Power Generation

March 25, 2015

**Re: Upper North Fork Feather River Hydroelectric Project, FERC Project No. 2105
Draft Environmental Impact Report, November 2014**

PG&E's Specific Comments on the DEIR

Figure 1: Monthly Comparison of Thermal Regime at Three Stations in the Belden Reach

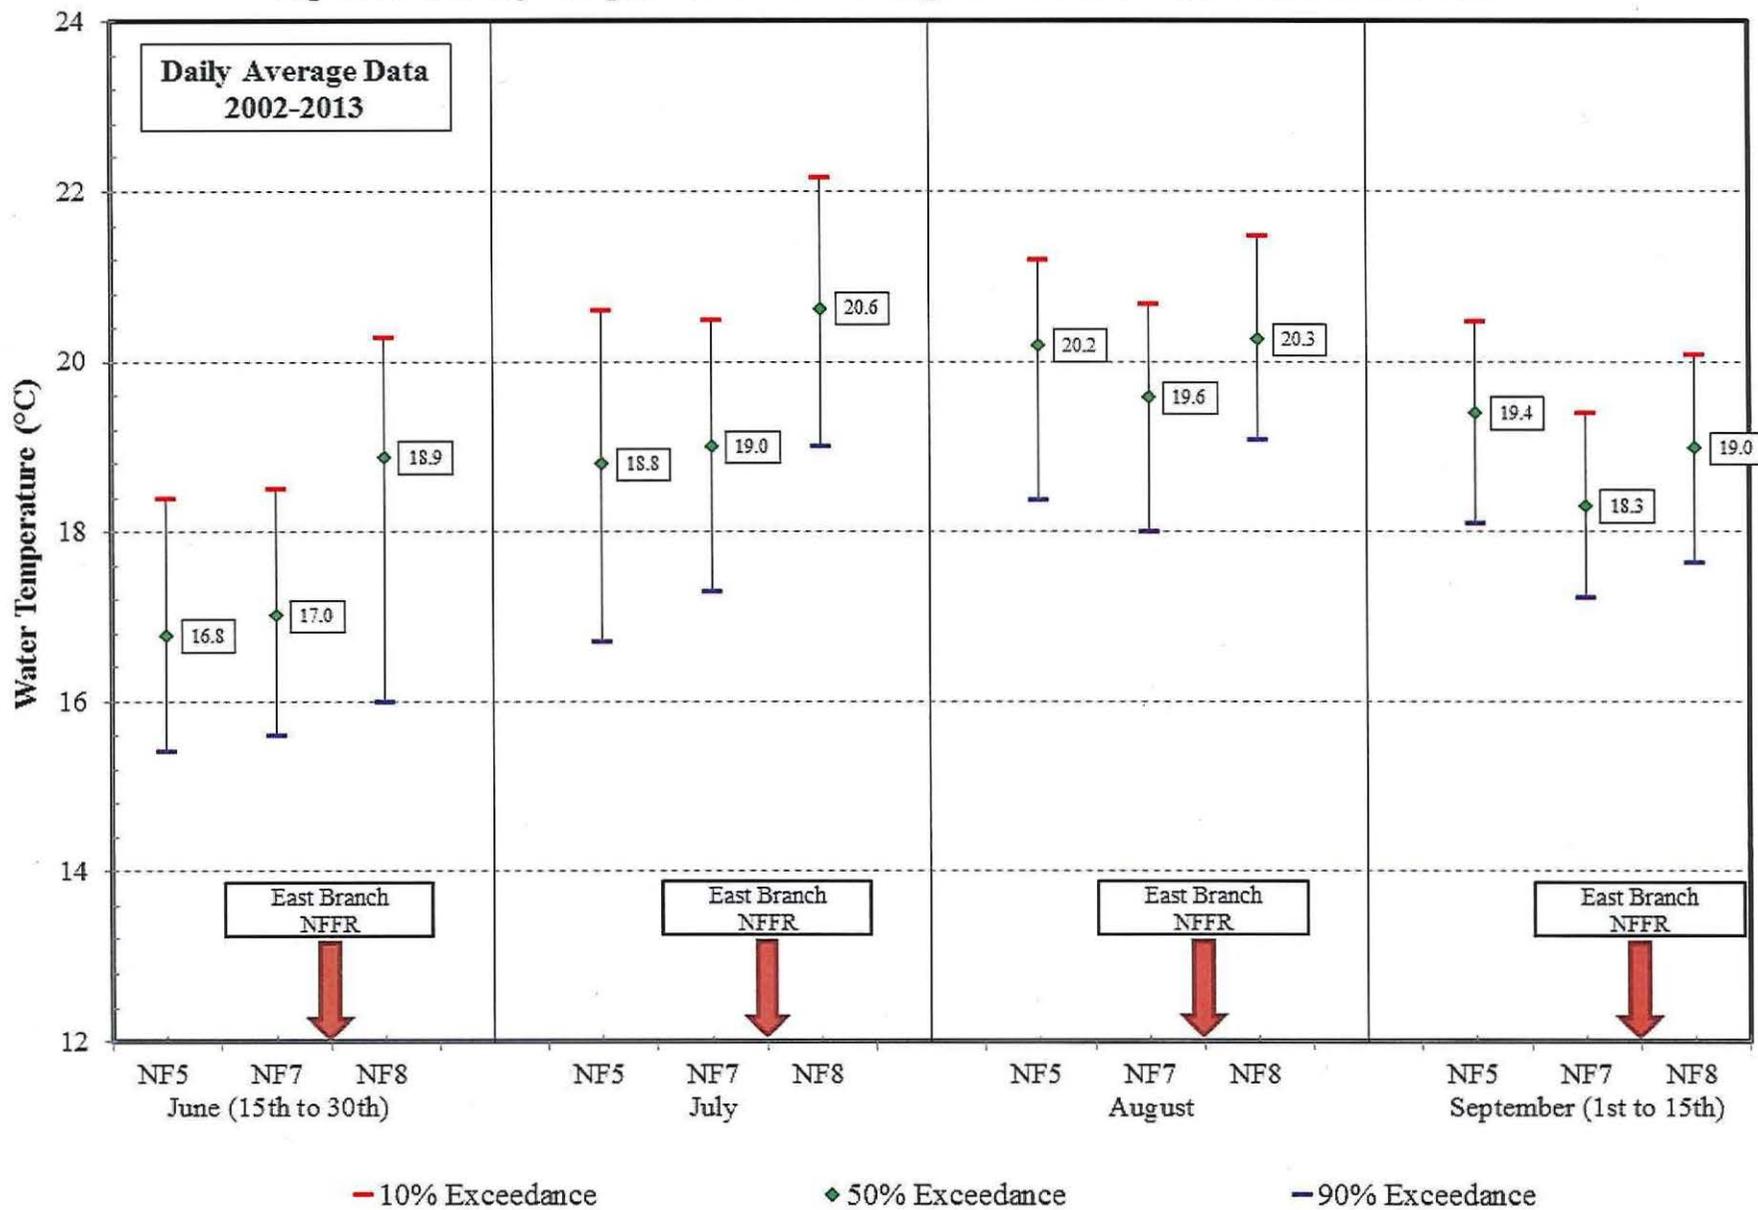
For the Belden Reach, there is little to no information to support the statement above. With respect to water temperature, Figure 1 (above) shows the results of eleven years of water temperature monitoring in the Belden reach (2002-2013). The median heating in the reach from Belden Forebay to just above the East Branch NFFR is 0.2 ° C in June and July, and actually cools in August and September. At no time is the heating greater than the 5 ° F (2.7 ° C) objective stated in the Basin Plan. Even after the confluence with the East Branch (a typically warm, non-project affected branch of the NFFR) the water temperatures do not exceed the Basin Plan objective for the Belden reach.
